ADDENDUM # 16

CAPITAL PROJECT 3414: CONSTRUCTION OF NEW HIGHWAY FACILITY

**Questions and responses to RFI's #37, 38, 41, 43.
Questions and answers 186 through 197.**

PORTION OF DWG
0.01.202 PREPARED
BY MCLAREN ENGINEERING

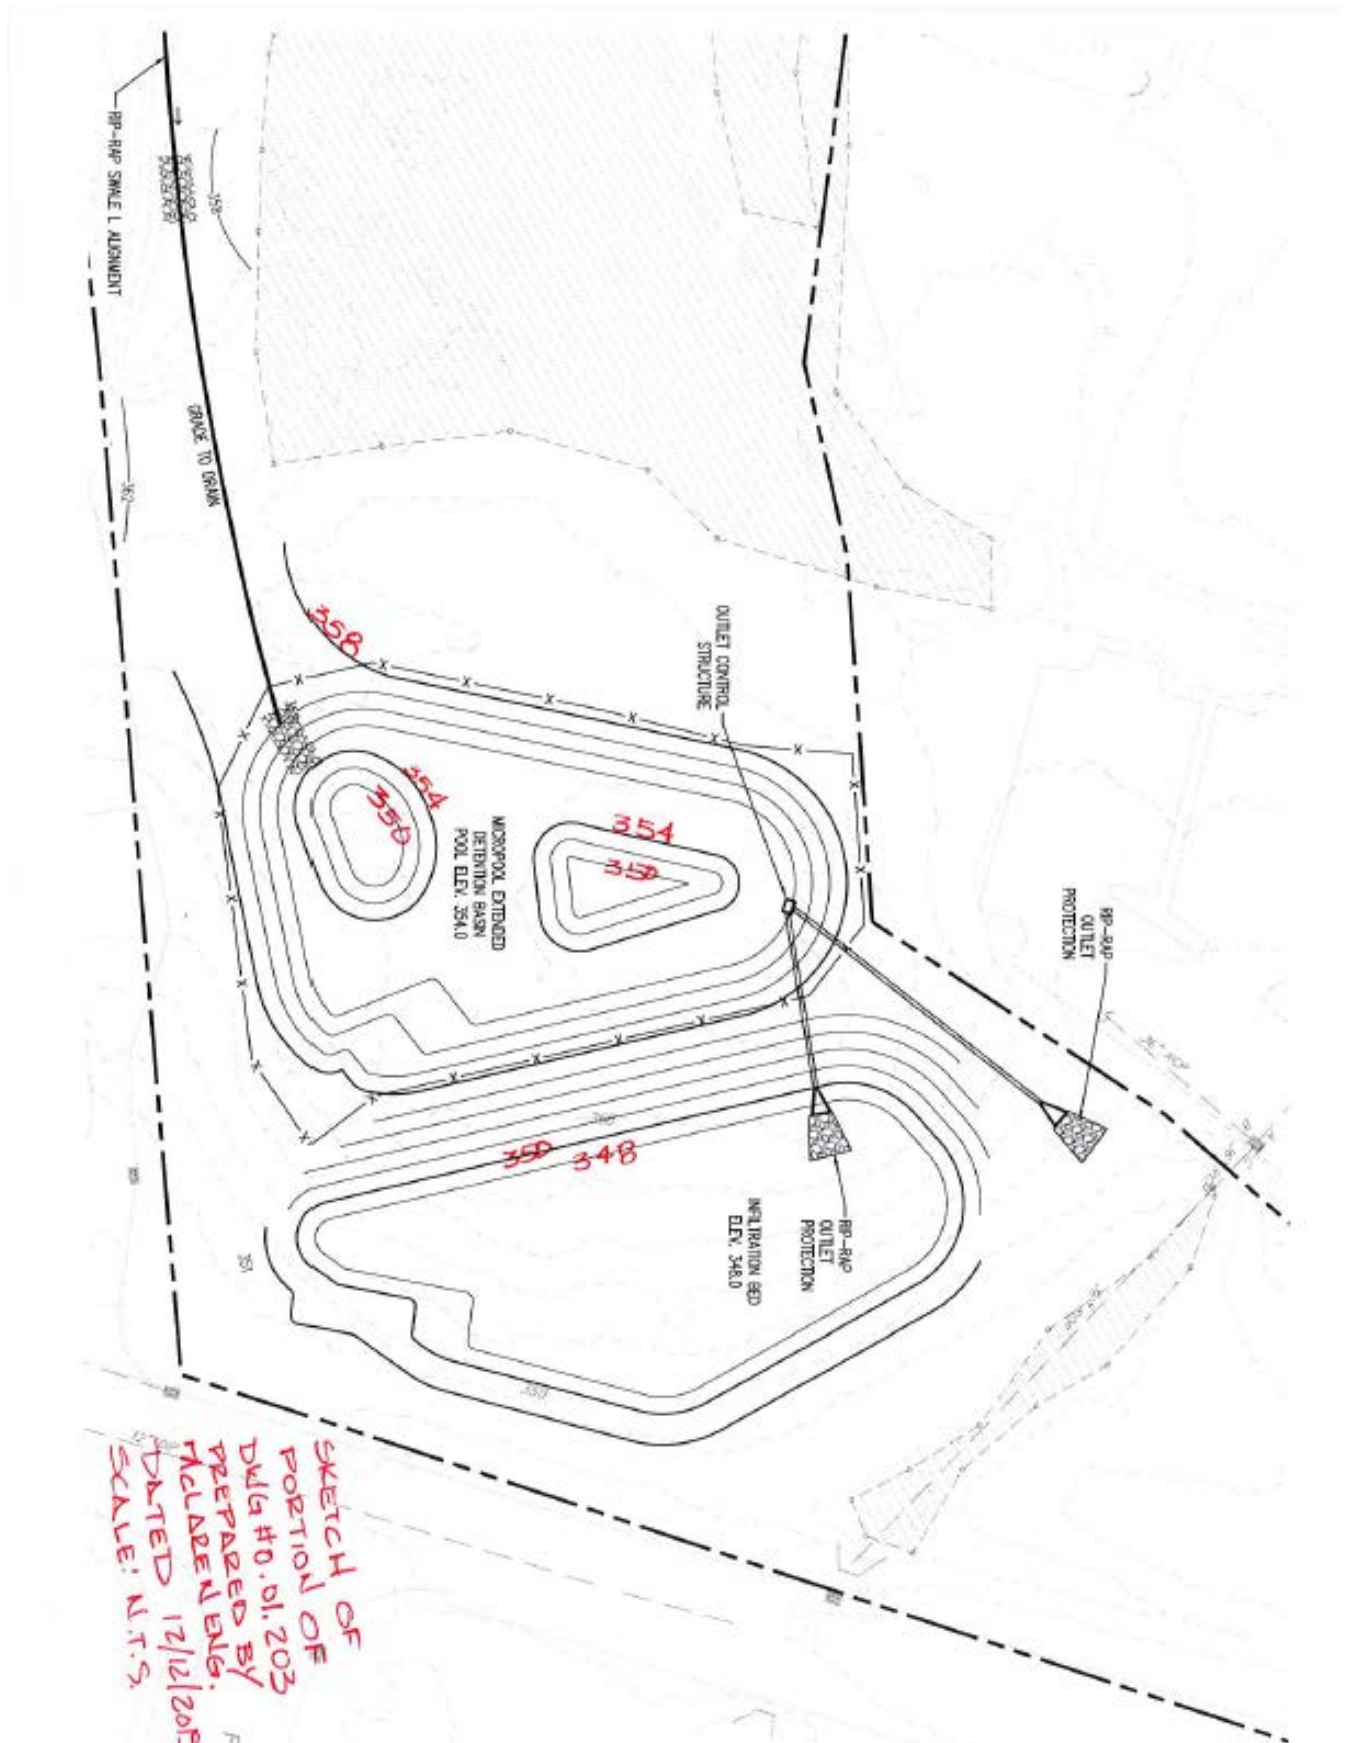
194. Re: The proposed grades at the NW corner of building No. 6 on Dwg. No. 0.01.202 The grades indicated in this area appear to be incorrect. The 440 contour is incomplete, the rim elevation of structure No. 45 is 439.40 & the spot elevation on the corner of the adjacent concrete pad is 443.50. Please clarify the grades in this area. **(RFI HT08)**

Response: See following sketches.
